Vogtle Electric Generating Plant
License Renewal - Responses to 04/28/2008 RAIs

Responses to April 28, 2008 License Renewal RAIs

Vogtle License Renewal Audit Questions and Answers

Figure 1: Design Transient for Fast Transient

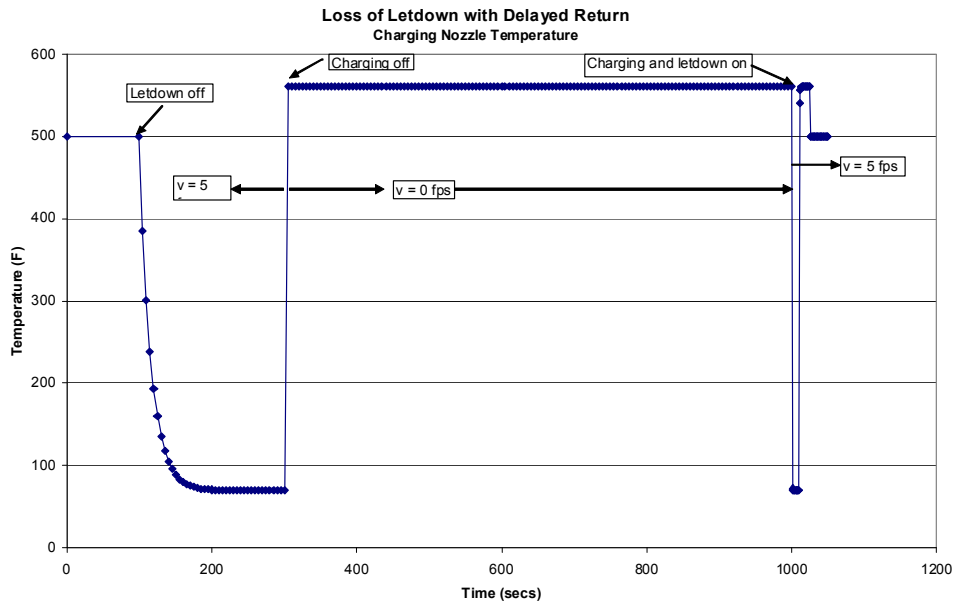
- a. Figure 1 and Figure 2, the temperature transient curves for the charging nozzle, are missing from the response. Please provide them.
- b. The locations for the charging nozzle and the surge line hot leg nozzle are at the safe-end region. Confirm the critical fatigue locations are at the safe-end region and provide supporting analysis results.

- a. When the attachment to NL-08-0228 was converted to pdf format, the page with Figures 1 and 2 was inadvertently left out. They are included below.
